## **Sand Management Site Monitoring Well Discussion**

**Boone, Iowa**

**February 2026**

## Response to IDNR Comment letter of January 7, 2026

Figure 1  
January 2026

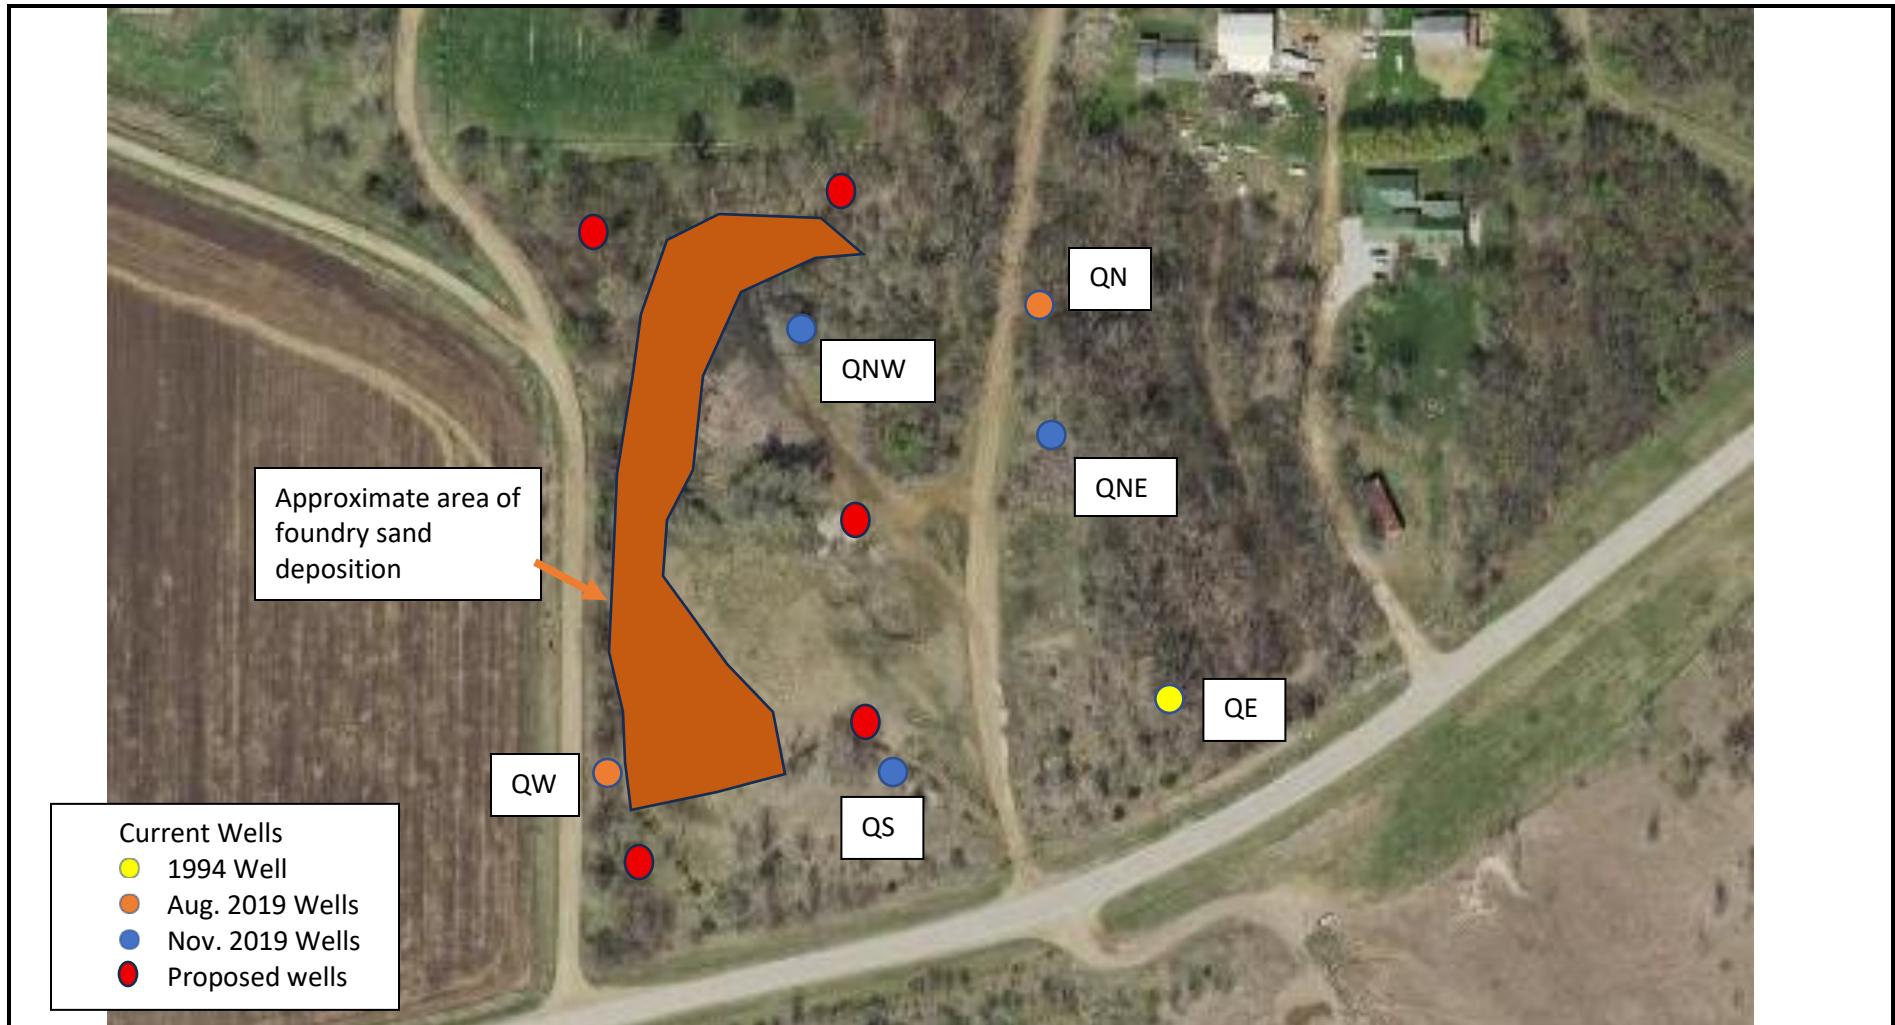
IDNR has requested discussion regarding the placement of new groundwater monitoring wells at the Besser Quinn Sand Management site near Boone, Iowa.

Proposed locations for the monitoring wells will consider the area filled with the foundry sand and then place the wells in natural soils adjacent to the fill area. Figure 1 notes the proposed locations. It is anticipated that all the wells will be bedded in the clayey soils noted in the current monitoring wells other than MW QN.

Currently there are six monitoring wells at the Sand Management site, five wells are proposed to replace the current monitoring wells. The noted proposed locations are presented in a general area adjacent to the deposited sand. Final field locations of the monitoring wells will be respective of access to the location and ability to position a drill rig for the advancement of borings and the installations of the wells. Once the wells are installed, they will be mapped both horizontally and vertically. The vertical mapping will associate the nearby Des Moines River bridge with the sand management site to facilitate height of river measurements along with the depth to groundwater measurements of each future sampling event.

Proposed well locations in red.
